SAFETY EVALUATION BY THE OFFICE OF NEW REACTORS
LICENSING TOPICAL REPORT MUAP-07007-P (REVISION 5)
“HUMAN SYSTEM INTERFACE SYSTEM DESCRIPTION AND HUMAN
FACTORS ENGINEERING PROCESS”
MITSUBISHI HEAVY INDUSTRIES, LTD.

Figure 1: HFE Design Process for Japanese Standard HSI System

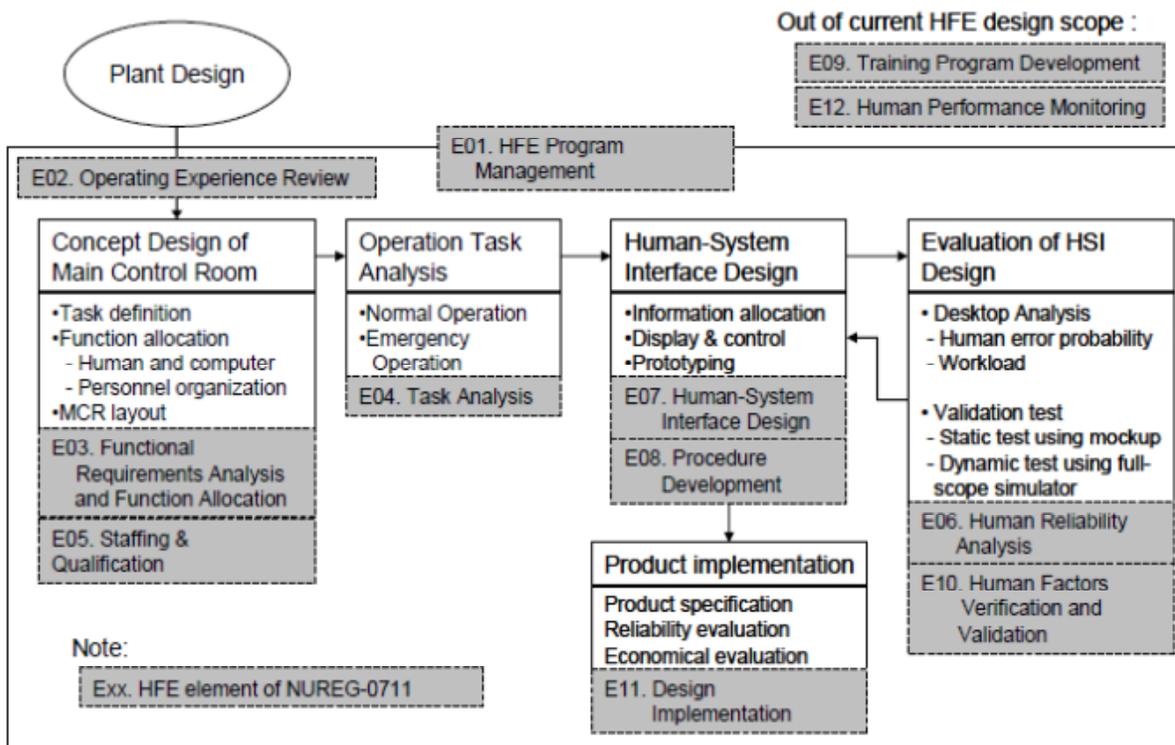
This process contains the major elements of NUREG-0711.

Figure 2: SOFT SWITCH

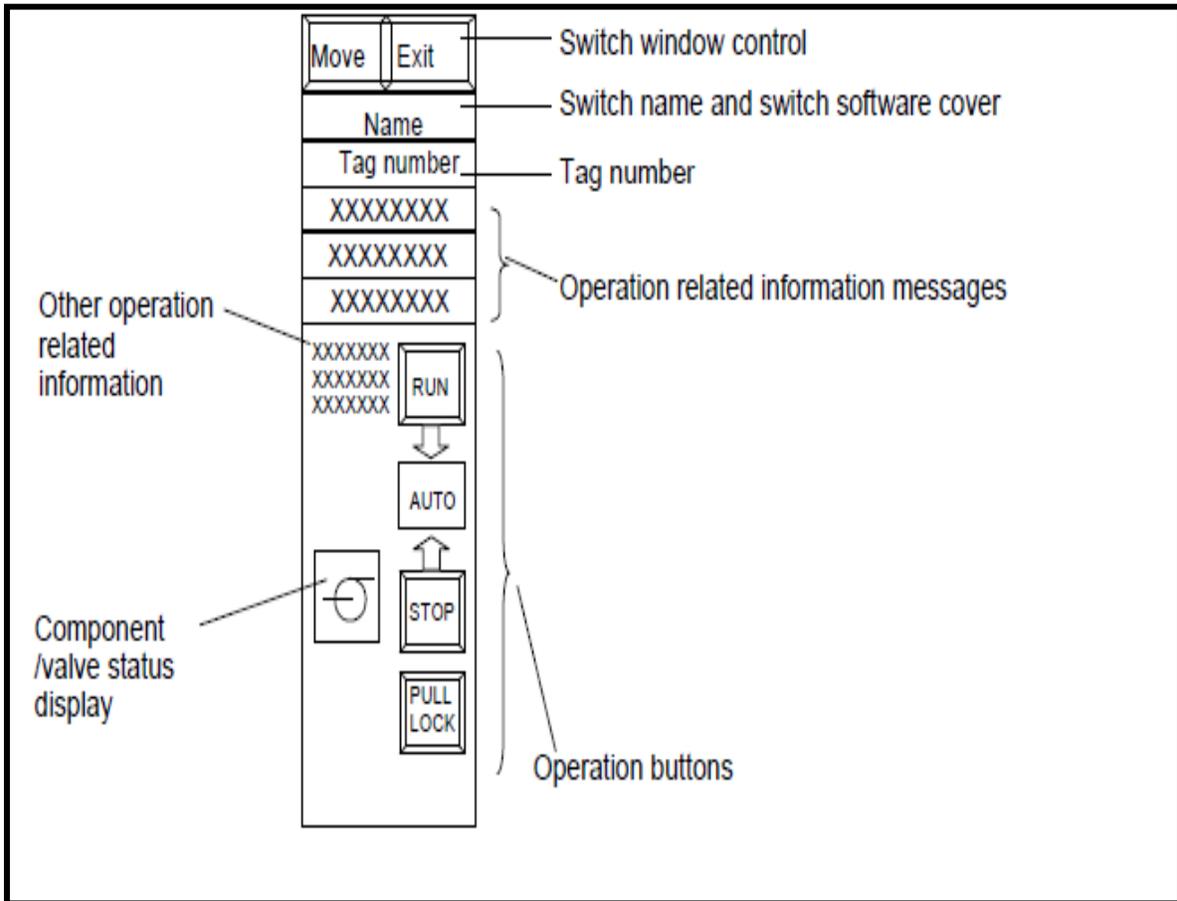
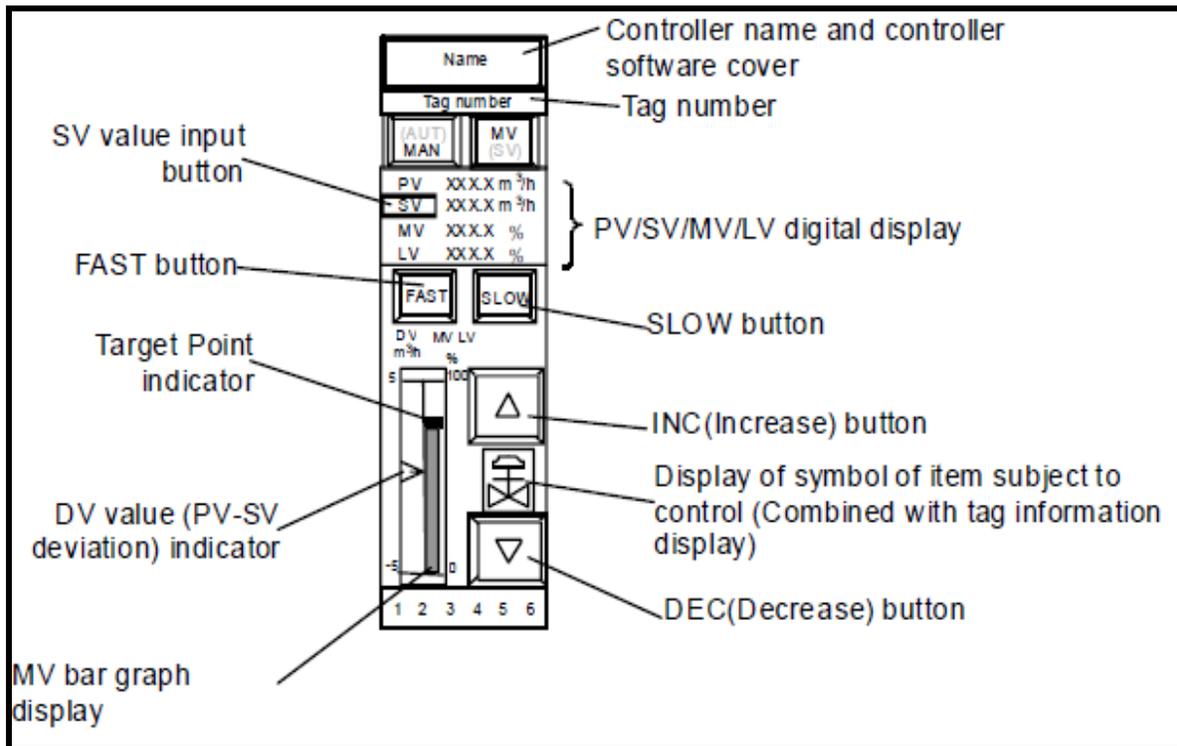
Figures 2 and 3 of a typical soft switch and a soft controller are provided below to help illustrate the HFE design that has been incorporated in each.

Soft control input is made by way of discrete-adjustment interfaces usually in the form of a button (i.e., start/stop, open close for a soft switch an increase/decrease buttons for controller settings). Discrete verses continuous-adjustment interfaces are preferred because the settings can be established by fairly gross movements. For controllers, setpoints can also be input using a numeric keypad function. Immediate feedback on the control activity is provided via the component status icons and in the case of controllers the bar graph display of target, process and deviation values. Since controllers provide continuous control functions they can be difficult to use due to digital system processing delay. To avoid the stress, confusion, and overshoot often caused by typical manual demand feedback indication delay, the soft control system accepts the demand signal, displays the target point in the manual value bar and sends the target values to the controller. A discrepancy between the demanded value and the value in the controller is easily seen by the operator.
